## DEVIATION REQUEST AND DECISION FORM

Project Name :	Crossroads North
Schedule No.(s) :	5408001008, 5408001029, 5408001032, 5408001033, 5408001034, 5408001041, 5408001042, 5408001050, 5408001051, 5408001052
Legal Description :	LOTS 12, 13, 14, 15, 16 AND 18, HILLCREST ACRES, ACCORDING TO THE PLAT THEREOF RECORDED MAY 12, 1960 AT RECEPTION NO. 153860, EXCEPT THAT PORTION ACQUIRED BY THE DEPARTMENT OF TRANSPORTATION, STATE OF COLORADO AS DESCRIBED IN RULE AND ORDER RECORDED APRIL 28, 2004 UNDER RECEPTION NO. 204068322, AND EXCEPT THOSE PORTIONS CONVEYED TO EL PASO COUNTY BY AND THROUGH THE BOARD OF COUNTY COMMISSIONERS OF EL PASO COUNTY, COLORADO BY SPECIAL WARRANTY DEED RECORDED DECEMBER 17, 2014 AT RECEPTION NO. 214116021 AND RECORDED DECEMBER 17, 2014 AT RECEPTION NO. 214116022, COUNTY OF EL PASO, STATE OF COLORADO. LOT 17, HILLCREST ACRES, COUNTY OF EL PASO, STATE OF COLORADO, EXCEPT THAT PORTION CONVEYED TO EL PASO COUNTY BY AND THROUGH THE BOARD OF COUNTY COMMISSIONERS OF EL PASO COUNTY, COLORADO BY SPECIAL WARRANTY DEED RECORDED DECEMBER 30, 2014 AT RECEPTION NO. 214119767. LOT 19, HILLCREST ACRES, COUNTY OF EL PASO, STATE OF COLORADO, AS AMENDED BY SURVEYOR'S STATEMENT RECO

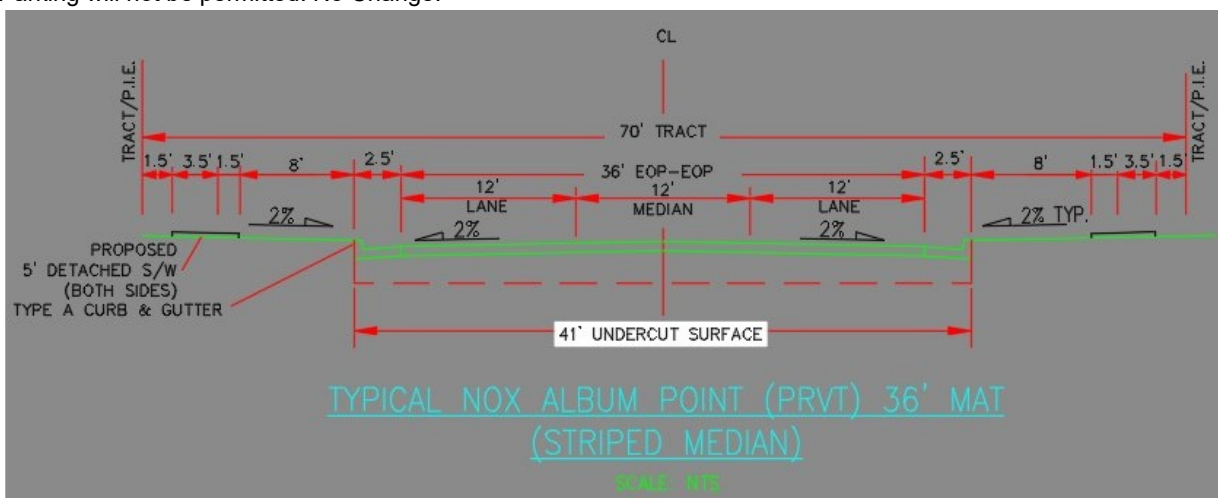
A deviation from the standard Urban Non-Residential Collector Roadway Cross Section for Pro Omnibus Heights and Nox Album View is requested. The standard cross section includes two travel lanes (12'), a striped median (12'), and two shoulders (6') within a 48-foot wide pavement mat; two 2.5-foot curb and gutter at the end of the pavement mat, two eight (8) foot (typical) landscape/tree lawns, two five (5) foot detached sidewalks all within an 80-foot ROW. A deviation from the minimum centerline radius for Urban Non-Residential Collector Roadways is also requested. The minimum radius is 565 feet.

The proposed private road cross section includes the following deviation(s) from standard ECM Standards for an urban residential collector section. Requesting;

- 70-foot Tract. Typical cross section is within an 80-foot Public ROW.
- 36 foot pavement width, where typical cross section has a 48' pavement width.
- Two 12-foot travel lanes with NO 6' shoulders, where typical cross section has two 12-foot travel lanes with two 6' shoulders.

- Striped 12' median, whereas typical cross section has 12' striped median. No Change.
- 5-foot detached sidewalk, where typical cross section has 5' detached sidewalks, No Change.

- 200' minimum centerline radius (standard for urban local roadways) whereas typical cross section is 565' minimum centerline radius.
- Two 5' Public Improvement Easements, whereas typical cross section has none.

- Two 8' landscape/tree lawns. Typical cross section has two 8' landscape/tree lawns. No. change.
- 25 MPH design speed/25 MPH posted speed (urban local), whereas typical cross section is 40/35 MPH.
